CITY PLANNING COMMISSION
 1231 P STREET, SUITE 200, SACRAMENTO, CA 95814

- APPLICATION:**
- A. Negative Declaration
 - B. Rezone 1.0+ vacant acres from Standard Single Family (R-1) to Alternative Single Family (R-1A) zone.
 - C. Tentative map to divide 1.0+ vacant acres into six "Petite" home lots and one duplex lot.
 - D. Special Permit to develop six "petite homes" and one duplex in the Single Family Alternative (R-1A) zone.
 - E. Variance to reduce the required 25 foot side yard setback to 10-1/2 feet in the Multiple Family (R-2B) zone for a proposed eight unit apartment complex (continued to August 11, 1988 for re-noticing).

LOCATION: 2840 Taft Street

P-88-267

STAFF MODIFIED ELEVATIONS

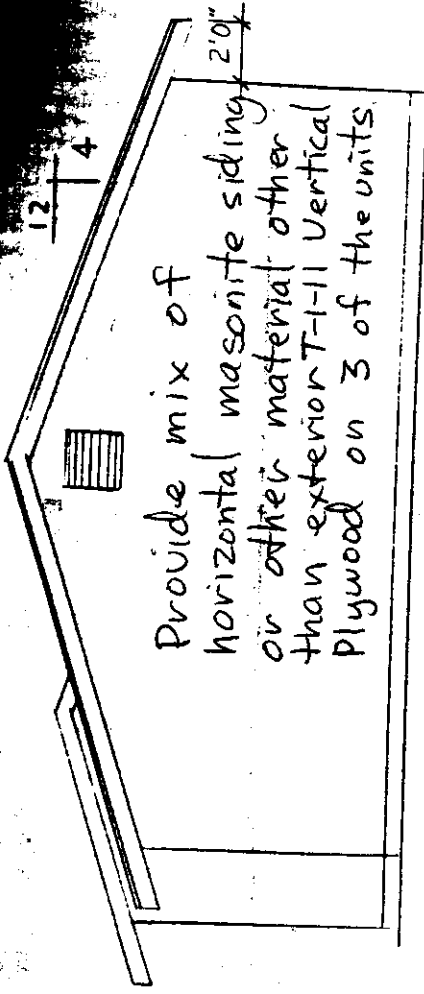
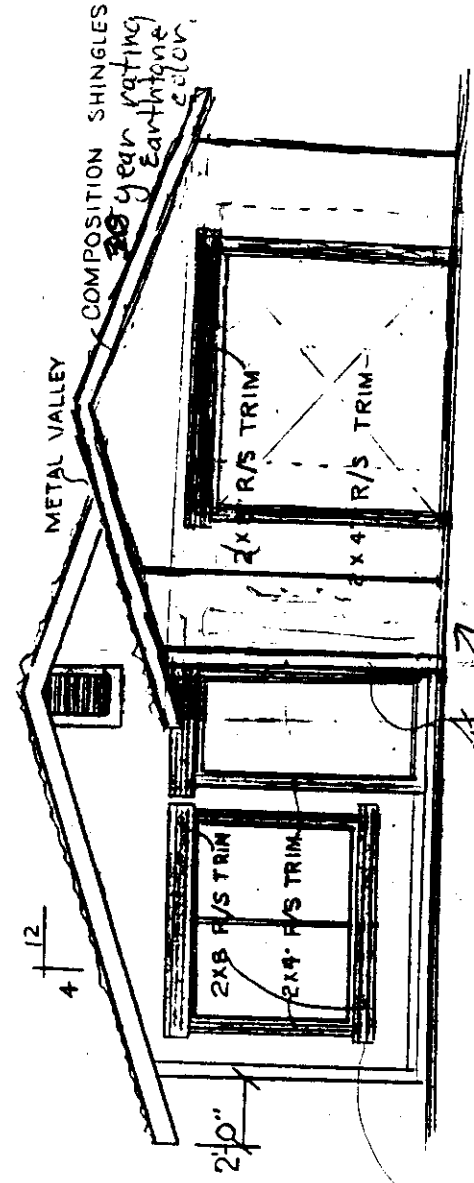
Staff has reviewed the elevations for the single family dwellings and suggest the following modifications:

1. The garage should be moved three feet to the side to increase the building's width to 30 feet. With the increased width, three feet can be added to the area between the garage and entry way. Staff recommends decorative trim or lattice elements to be added to break up the elevation as viewed from the street.

Increase SF: 1/4" = 1'0"
from Garage to main entrance

1. The applicant shall revise the building elevations to show a dwelling with three additional feet of width between the entrance and garage as shown on the staff modified front elevation for a total building width of 30 feet. A decorative trim lattice or similar element is to be shown to provide variety to the front elevation.

RIGHT ELEVATION

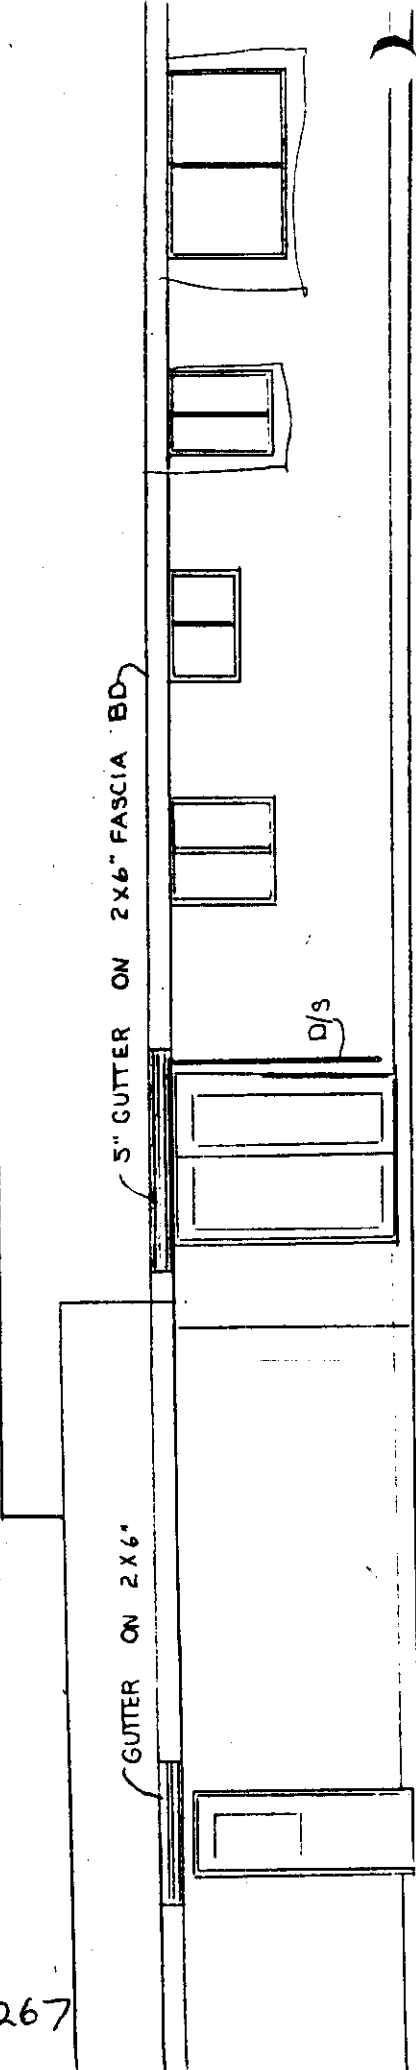
Pls Add 4" Board
Beneath
windows
